# Technical Note

East Hill, Hempstead Valley

17-035-009 Rev A

Transport Assessment Addendum

Figure 5.1 – Geometry measurements – OS map with overlaid google earth image

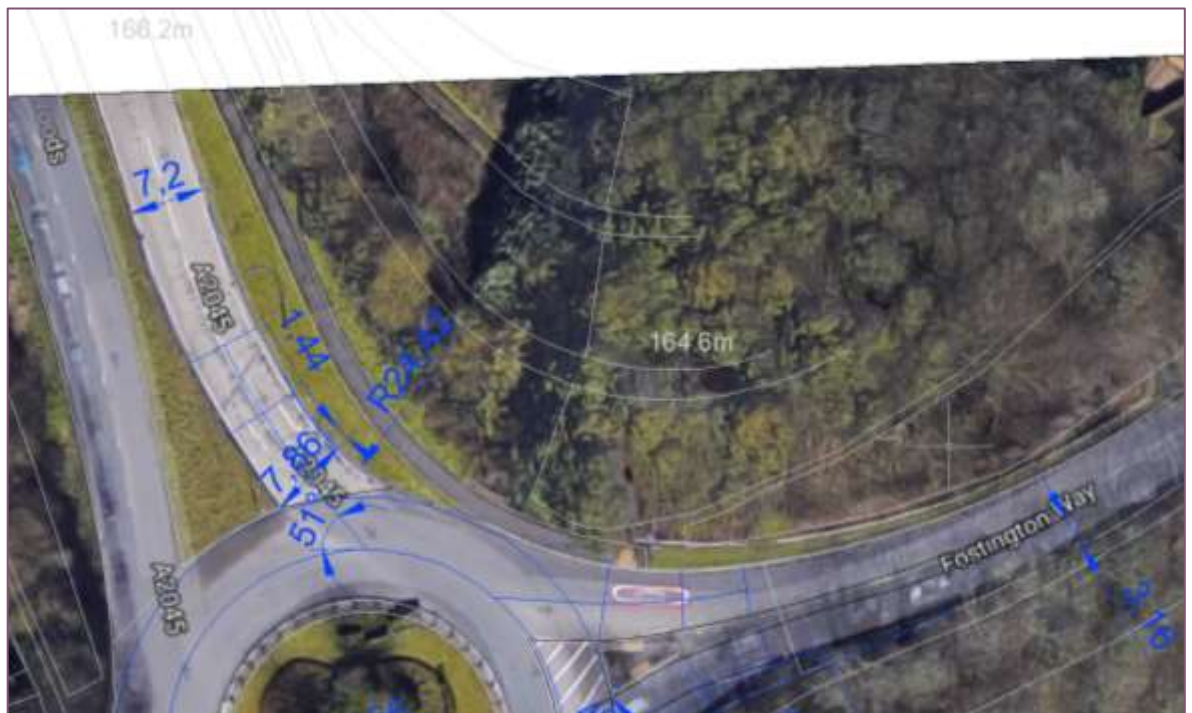
5.1.2 The comments received in regard to A2045 / Fostington Way Junction were as follows:

1. The entry width entered for the A2045 north arm may be over-estimated slightly;
2. The approach road half widths on the A2045 north and Fostington Way east arms may be over-estimated a little.

5.1.1 In response to comments from HE regarding the geometry measurements used for the modelling of the roundabout of A2045 / Fostington Way, C&A has undertaken a review of the input parameters to the Arcady model.

5.1.3 Having reviewed the geometry measurements obtained from OS mapping and checking these have been input correctly, it is maintained that the geometry inputs used for the purposes of the TA are appropriate and fit for purpose, as shown in Figure 5.1 above.
